09-0351  
12-10-09 1

**Notes for 12/8/09 Discussion of Line of Sight Problems on Sierrama Dr. and Rezoning of Z08-0026**

FIGURE 2

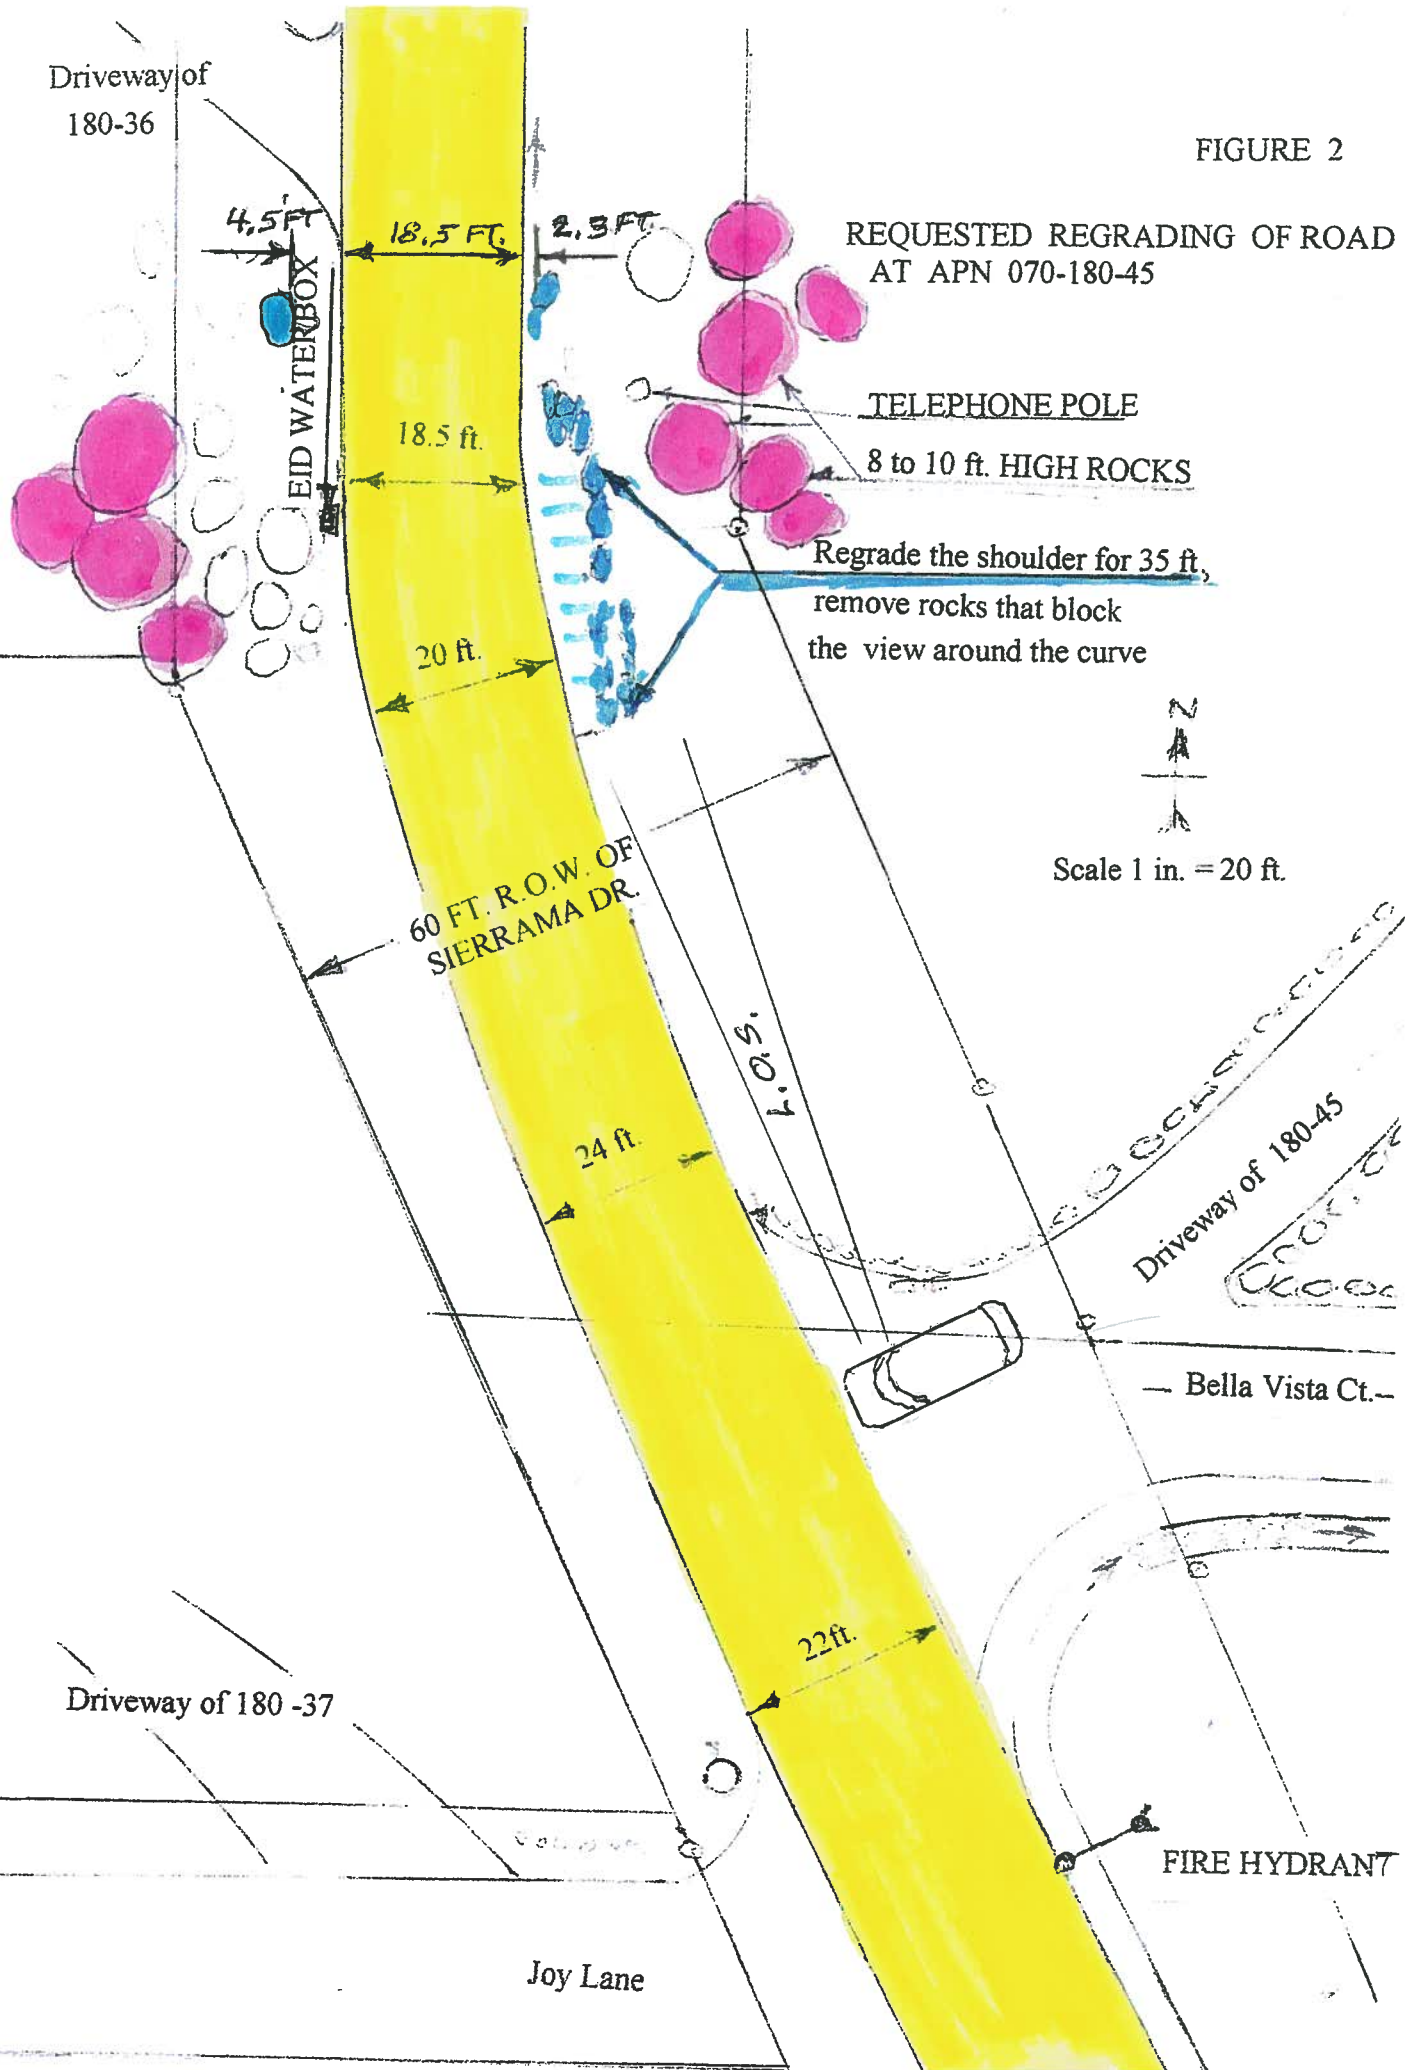
**C.) I have recently improved the line of sight from my driveway to the north from 50 ft. to 80 ft. This was partially due to cutting back the shrubs. It can be improved further. This was discussed in my letter of December 1 to Mr. Fong, with figure 2. I have extra copies of this figure 2. Figure 2 shows rocks on the east side of Sierrama Dr. that are colored blue. These rocks are 3 to 5 ft. above the road and 18 inches to 8 ft. from the paved surface. As I was pruning the shrubs in this area, some of the rocks came loose and fell into the ditch. I could not lift the larger rocks. However, regrading could improve the line of sight by removing about 15 rocks and dirt to reduce the 5 ft. height. This would increase the line of sight from about 80 ft. to 100ft. The cost would be about \$1000. We request that the Z08-0026 rezoning be made contingent on the developer doing this work.**

<sup>two</sup> To obtain the 150 ft., line of sight would require the removal of ~~the~~ large boulders that are about 3 ft. high and only <sup>28"</sup>~~18~~ inches from the paved road surface. It is difficult to estimate the cost since the rocks are on top of the 6" water main which could be broken by attempts to remove them. We would appreciate DOT comments on this.

Regrade the shoulder for 35 ft,  
remove rocks that block  
the view around the curve

ROAD SAFETY ON  
SIERRAMA DR.  
CURVES TO BE  
CORECTED ARE  
SHOWN IN RED

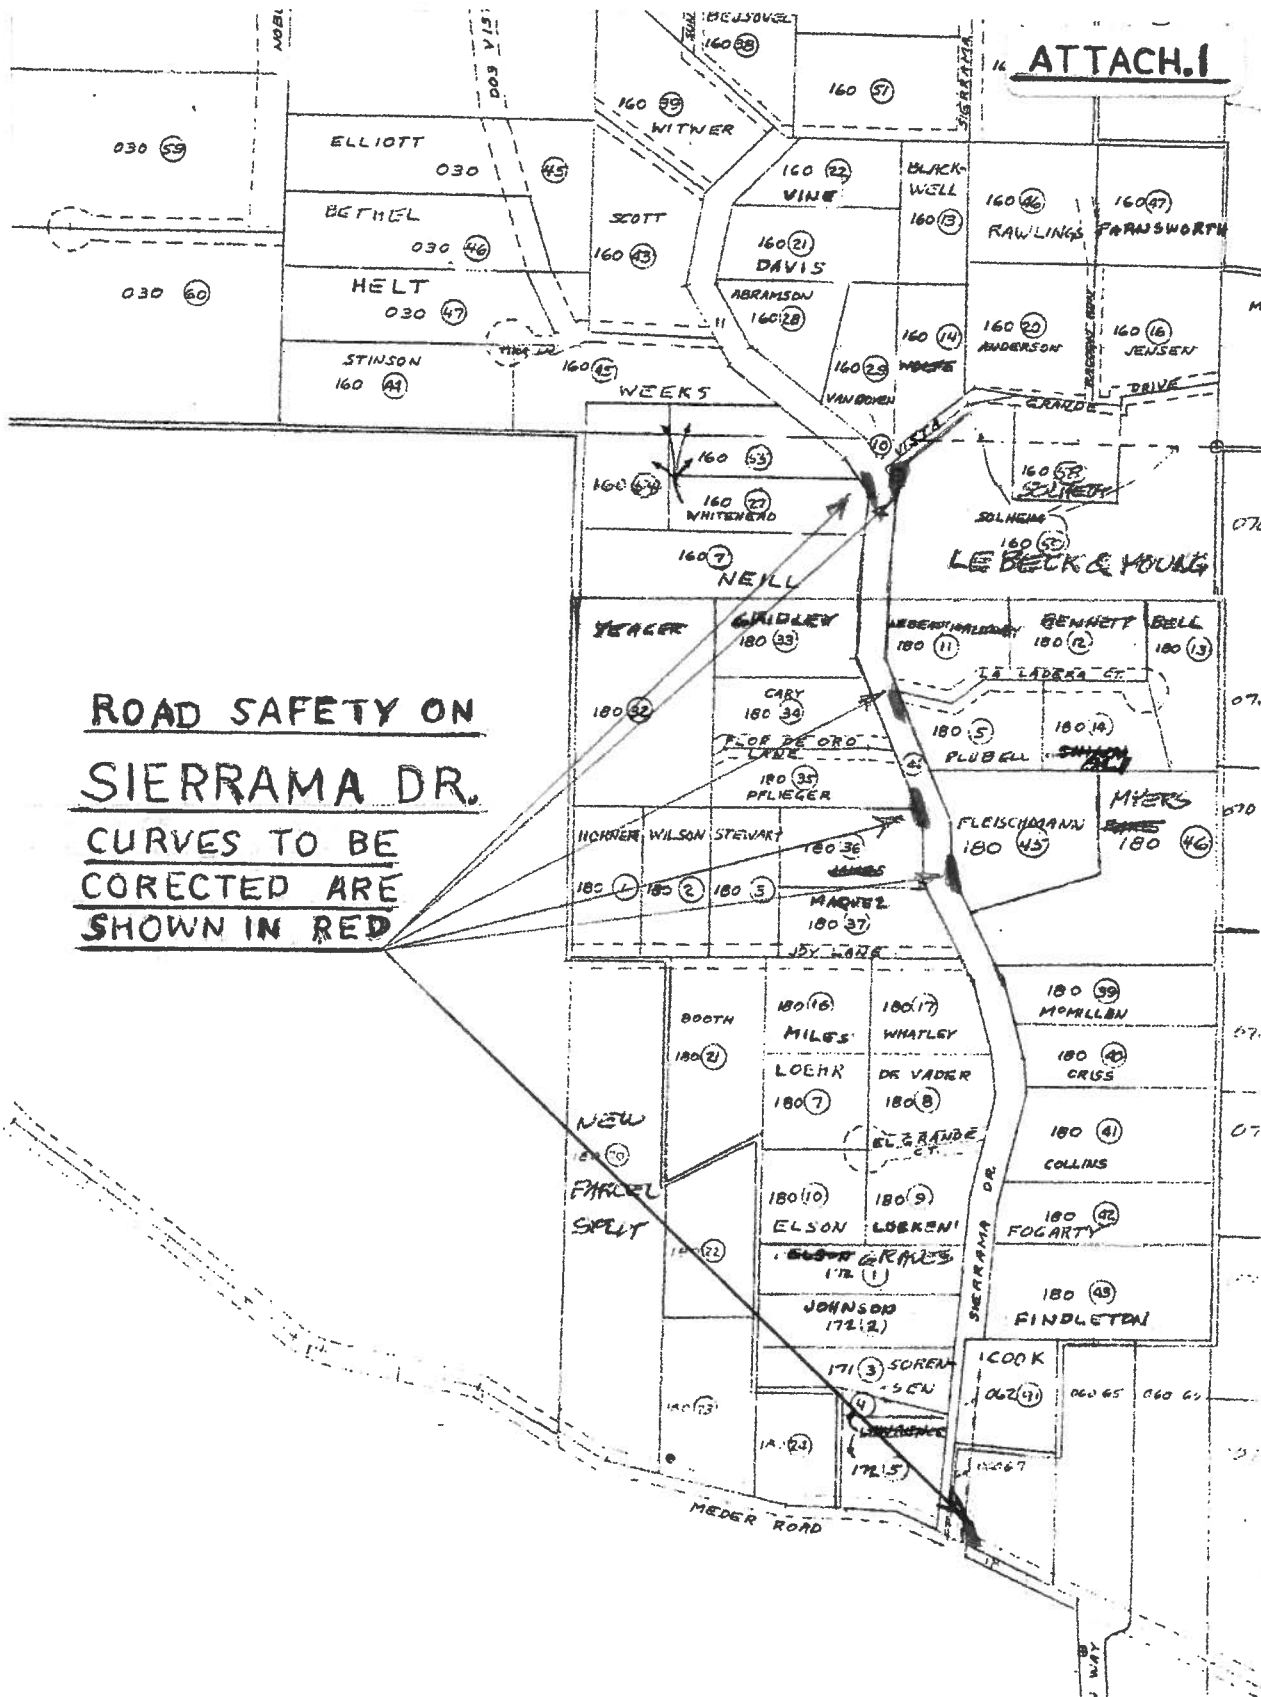
**A.) The area that needs improvement as marked by the northern most arrow on figure 1, is the on site improvements on the east and west side of Sierrama Dr. Please confirm that both sides will have the line of sight when traveling north and south equal to the desirable 150 ft.**

**B.) The two arrows shown on figure 1 just to the south of those discussed in A, indicate that vegetation blocks the view at the curves. These can be improved by cutting back the vegetation at a small cost. The partial blockage of the road view near La Ladera could be improved by cutting back a couple trees and bushes to be able to see cars pulling out of La Ladera. The view blockages from growth on APN 070-180-36 would require more substantial cutting to improve the view from its 20% of the desirable distance, to approach the 150 ft. that DOT recommends. DOT comments are requested.**
